- Sent via email –  
September 18, 2023

RE: Review of City of Richmond Hill's Draft OPA 18.5 – Yonge & Carrville/16th Avenue KDA

**Schedule C2 Map**

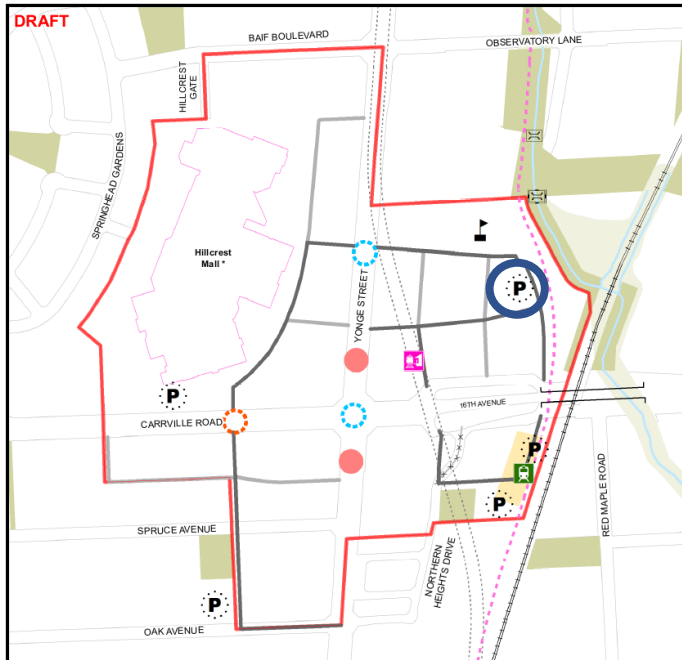
We seek an update from staff on our request for flexibility in the park location as shown on Schedule C2 such that the park location can be adjusted without the need for an OPA.

From a review of the existing Secondary Plans we note multiple examples of policy language consistent with our request that staff can draw upon in crafting a policy suitable for this Secondary Plan. Policy examples include,  
 -West Gormley Secondary Plan - S.8.6.5.2(d) & S.8.9.1(b)  
 -North Leslie Secondary Plan - S.9.6.6.2(a) & S.9.9.1(c)  
 -Yonge Bernard Secondary Plan - S.12.3(4)

Related to the requested flexibility in the park location we continue to have a concern with the prohibition in Policy 4.4.2.3 (2). Since the location of the north-south collector is conceptual and the limits of the greenway system are subject to further refinement (based on future study) to know the precise greenway limits we believe there is still potential for linear park space between the north-south collector road and limits of the greenway system.

We request the policies of the plan be revised to allow for this opportunity. The proposed revised language provided by email on Sep 12/23 does provide for relocation of the park to the north or south but not to the east. Allowing for a park east of the north-south collector will still allow for the desired views and access to German Mills Creek.

**Schedule C3: Market Promenade Relocation**

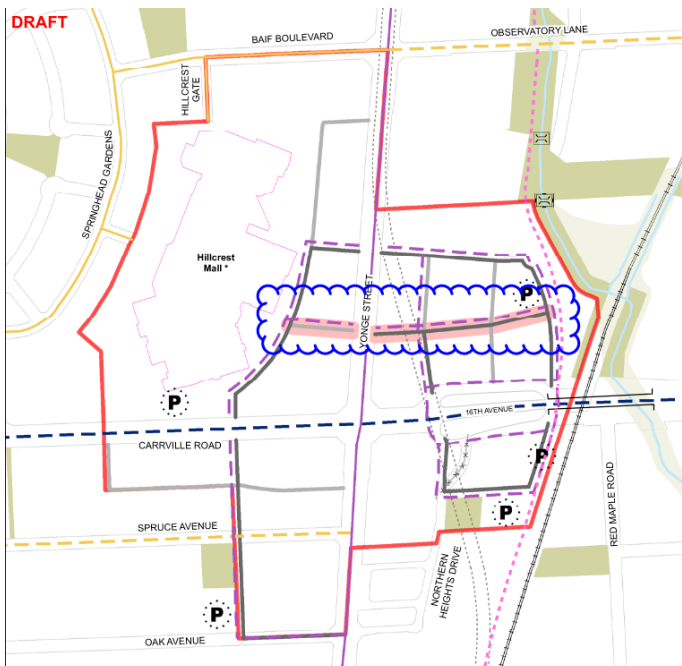
At our meeting on Sept 5<sup>th</sup>, Staff advised of the request from Oxford Properties to relocate the market promenade (on Oxford's property) further north to align to the signaled intersection on Yonge Street.

SmartCentres understands the reasoning behind Oxford's request and is open to adjusting the location of the market promenade on our property. However, we wish to discuss any specific adjustments to SmartCentres' lands that staff are considering before a change is implemented.

We would like to note that we are satisfied with the current location of the market promenade on our lands, as shown on Schedule C3.
